## **LIBERTY SUBDIVISION**

APPLICATION NUMBER 10 DATE July 21, 2011

APPLICANT Liberty Subdivision

DETAIL SITE PLAN

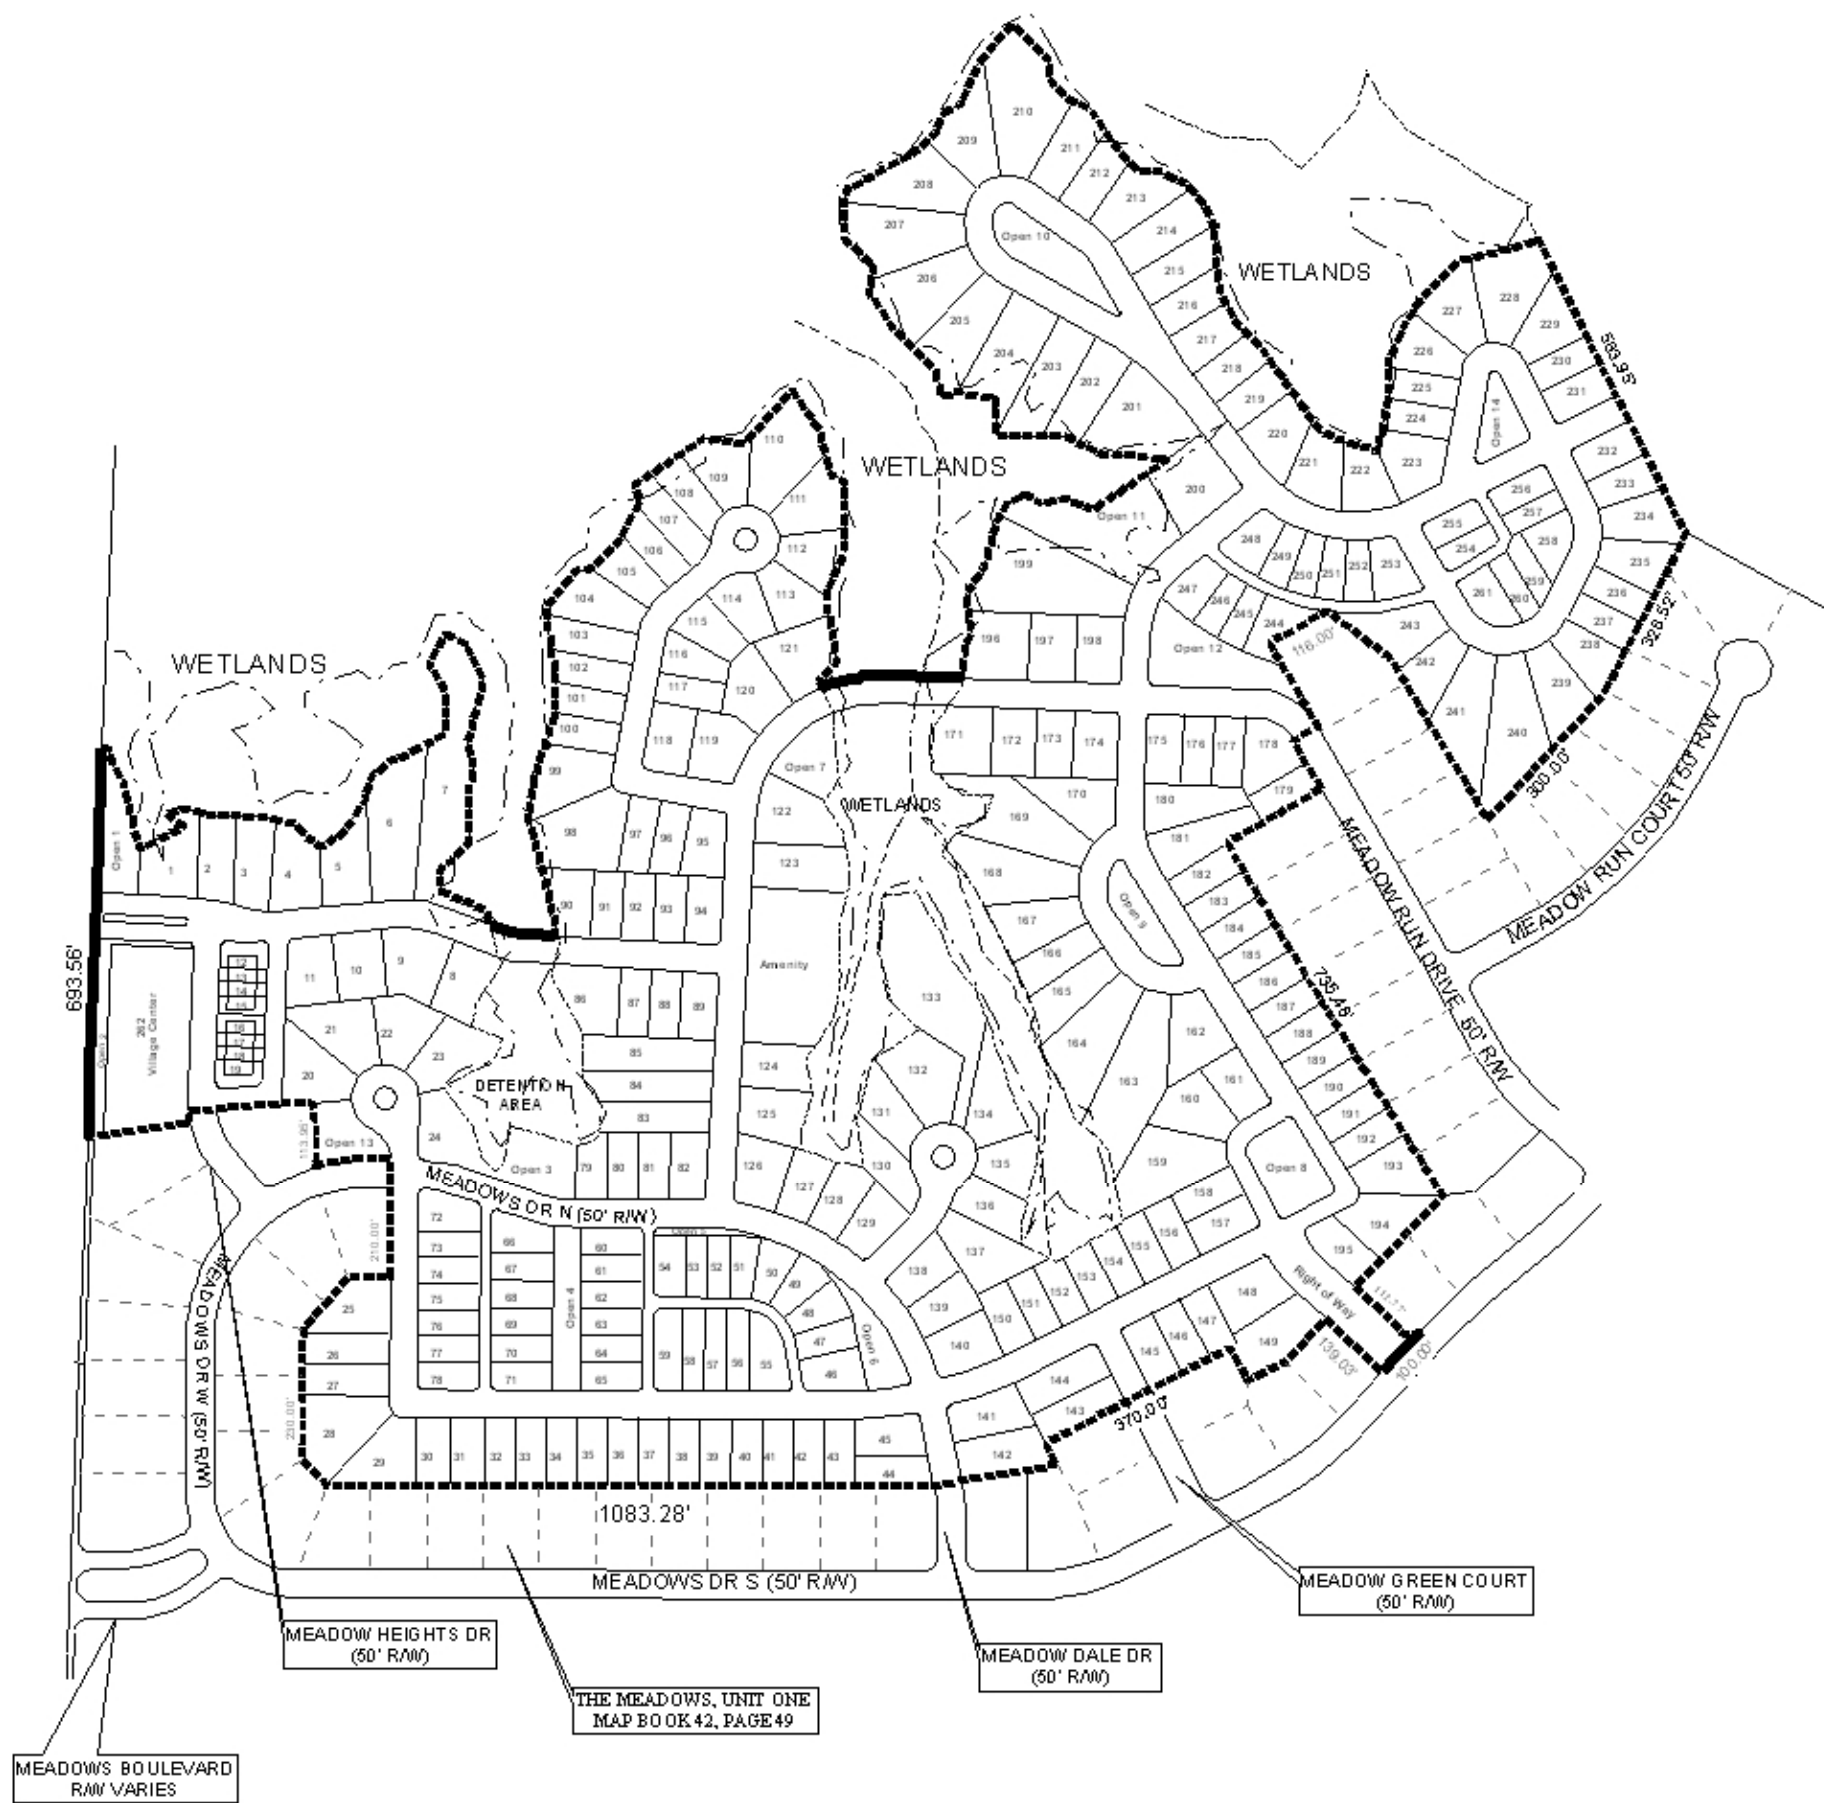
The proposed subdivision has frontage onto street stubs for The Meadows subdivision, all minor streets with adequate rights-of-way, and Schillinger Road South, a proposed major street with an existing right-of-way width of 80 feet. As Schillinger Road South is a proposed major street, its right-of-way should be 100-feet in width, thus sufficient right-of-way should be dedicated to Mobile County to provide 50 feet, as measured from the centerline of Schillinger Road South. With that said, the 25-foot minimum building setback line for all lots with frontage onto Schillinger Road South should be revised to reflect the right-of-way dedication.

Access management is a concern regarding the proposed subdivision fronting onto a proposed major street, and as it relates to lots within the proposed subdivision. One access to Schillinger Road South is depicted on the preliminary plat; therefore, a note should be placed on the plat stating that direct access to Schillinger Road South is denied for any lots fronting onto Schillinger Road South. Moreover, all lots are illustrated as being contained within the subdivision; therefore, a note should be placed on the plat stating that all lots (including corner lots) are limited to one curb each, with the size, design and location to be approved by the Mobile County Engineering Department and in conformance with AASHTO Standards.

It should be noted that Lots 7, 56-58, 84, 85, 133, 163, 164, 169 and 240 appear to exceed the maximum depth allowed by Section V.D.3 of the Subdivision Regulations. However, given the close proximity of the site to wetlands, much of the rear of these lots may not be developable; thus, a waiver may appropriate.

The site plan depicts several open areas and detention basins. A note should be placed on the Final Plat, if approved, stating that maintenance of the Common Area/Detention Area, and any other common areas, are the responsibility of the development's property owners.

- 1) dedication of sufficient right-of-way to provide 50', as measured from the centerline of Schillinger Road South;
- 2) the placement of ALL building setbacks and a table illustrating ALL setbacks on the Final Plat;

- 3) the placement of a typical lot setback for ALL size of lots to be illustrated on the Final Plat;
- 4) placement of a note on the Final Plat stating that direct access to Schillinger Road South is denied for any lots fronting onto Schillinger Road South;

- 5) the labeling of each lot with its size in square feet and acres, or the placement of a table on the Final Plat with the same information;
- 6) placement of a note on the Final Plat stating that all lots (including corner lots) are limited to one curb each, with the size, design and location to be approved by the Mobile County Engineering Department and in conformance with AASHTO Standards;
